ADDENDUM #1
FOR SPEC. 03-064
FOR
PUMP BUILDING ROOF REPLACEMENT AT
LINCOLN WATER SYSTEM ASHLAND

Addendum #1 for Spec. 03-064, for Pump Building Roof Replacement at Lincoln Water System Ashland, bids to be opened on Wednesday, March 5, 2003 at 12:00 noon.

This addendum includes detail CRS - 4 and is a supplemental to the specifications and are a portion of the work.

DETAIL NUMBER CRS - 4	Date FEBRUARY 19, 2003	Company Commercial Roofing Services, Inc.
	Drawn by B.W.S.	
	Scale N.T.S.	Project LINCOLN WATER SYSTEM - ASHLAND PUMP BLDG. ROOF REPLACEMENT

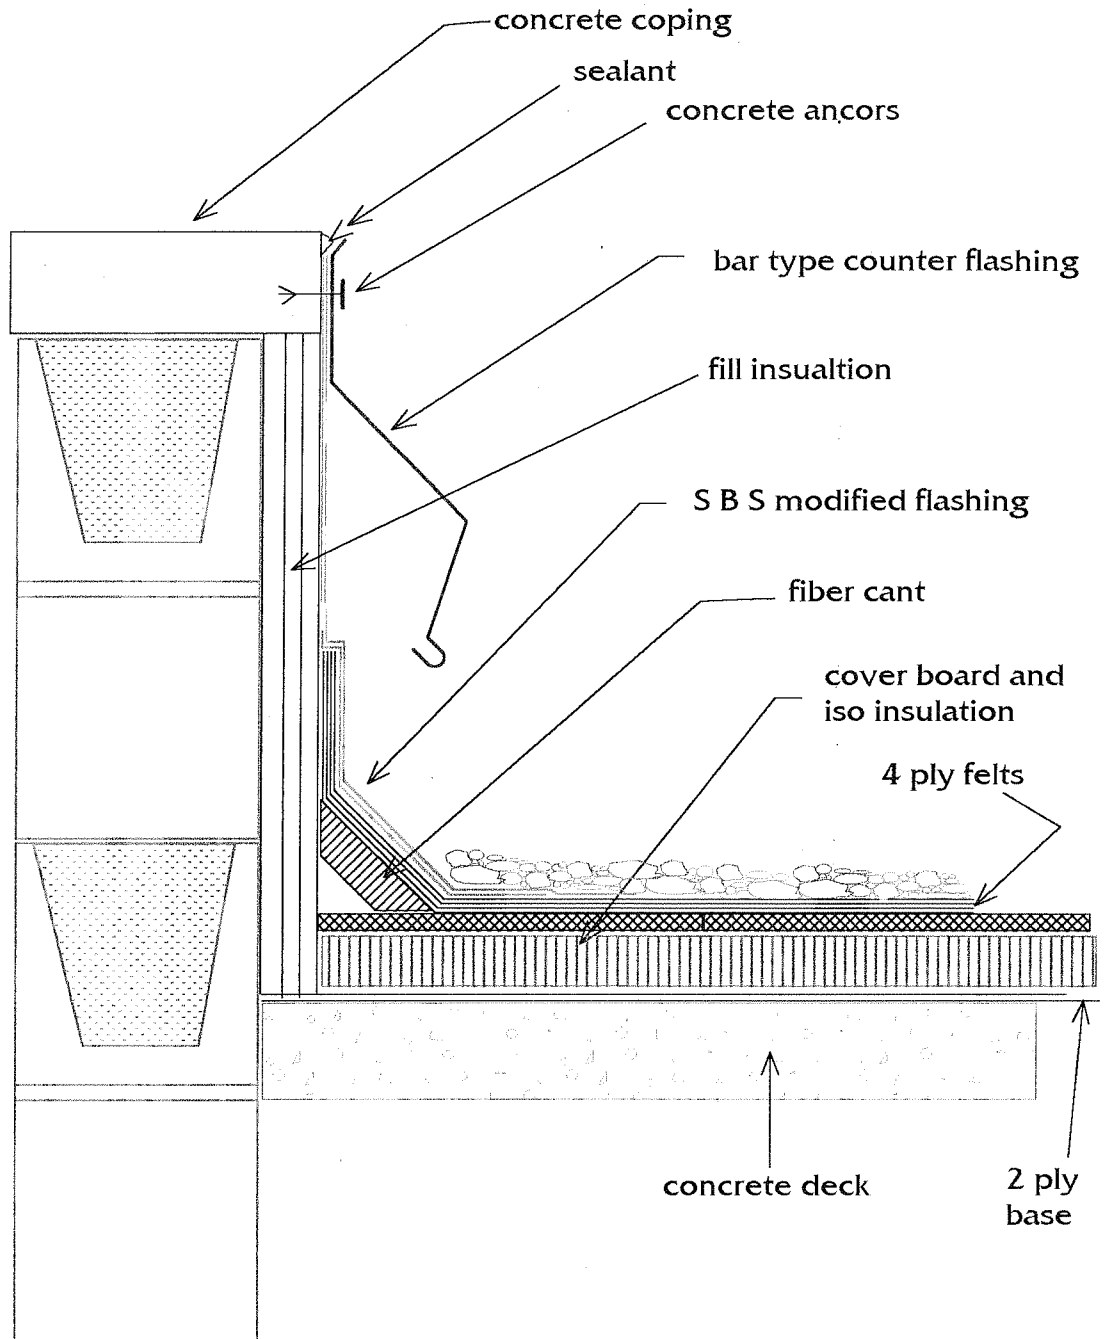
7. Detail CRS -4 will be used for the parapet walls on Roof Sections A, B, D, E, F, H, I and J due to height restrictions of the flashings being too low to install under the coping cap. This will consist of installing a perlite or wood fiber fill insulation to the walls set in hot asphalt, from the deck to the bottom of the coping cap, to fit even with the interior edge of the coping cap, installing flashing to the top of the coping cap and installing counter flashing. Concrete anchors are to be installed so that there is no damage to the top surface of the coping cap.
8. Roof section height elevations are as follows:
 - 1 story roof Section; B.
 - 2 story roof Sections; A, C, D, F, H and J
 - 3 story roof Sections; E and I
 - 4 story roof Sections; G and K
 - 5 story roof Section; L.
